# TECHNICAL MEMORANDUM

Utah Coal Regulatory Program

RE: Channel Repair Plan, Plateau Mining Corporation, Star Point Mine, C/007/0006, Task #4196

Plan views and cross sections of the channels were included with the application on Plate 2 (see cutouts below). The basic plan for repair of the channel is as follows:

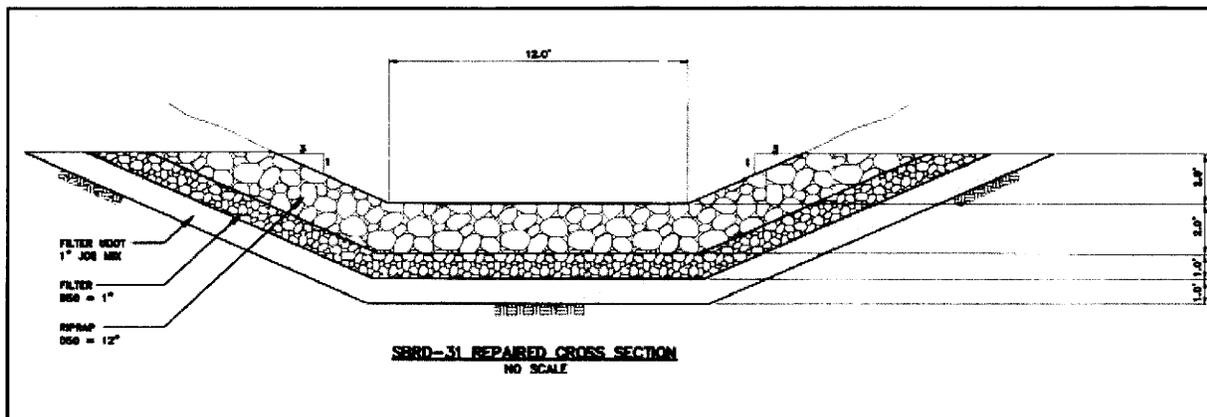
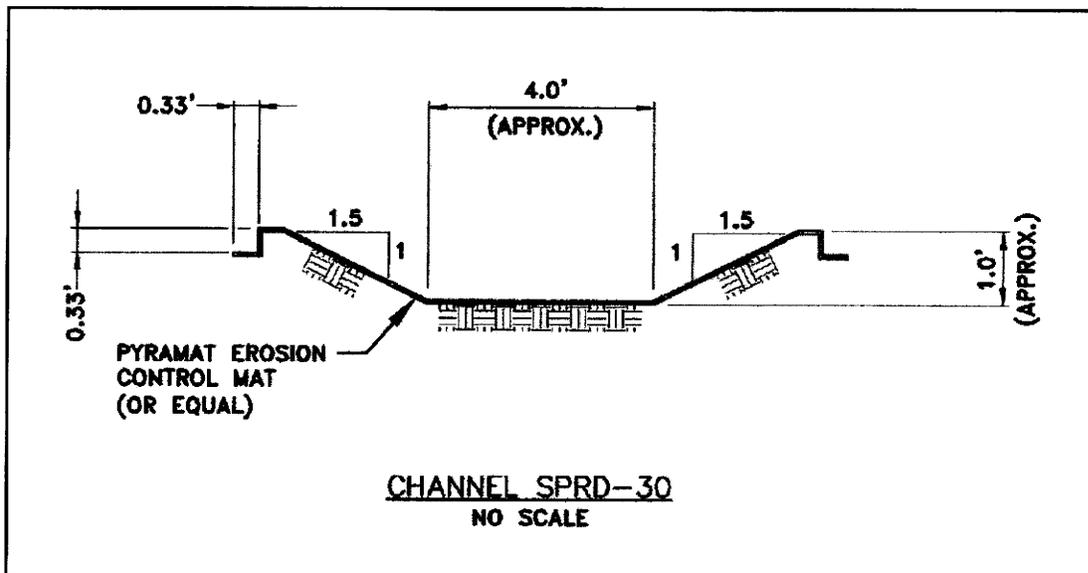
Plate 2 also indicates that D<sub>50</sub> = 24 inch riprap will be installed in a small section of the channel at an outlet from a 24-inch diameter downspout culvert. This culvert conveys water from a sedimentation pond that is maintained by others adjacent to the nearby coal slurry pile. Riprap sizing was increased in this area to dissipate energy in water discharging from the downspout.

The channel sections requiring repair will be graded as necessary to form a base for the repaired channel, with an allowance made for the placement of riprap and filter bedding. Filter bedding will be installed at the nominal thicknesses shown on Plate 2 beneath the riprap prior to placement of the riprap. The riprap will then be placed in the channel.

Drawings were properly certified.
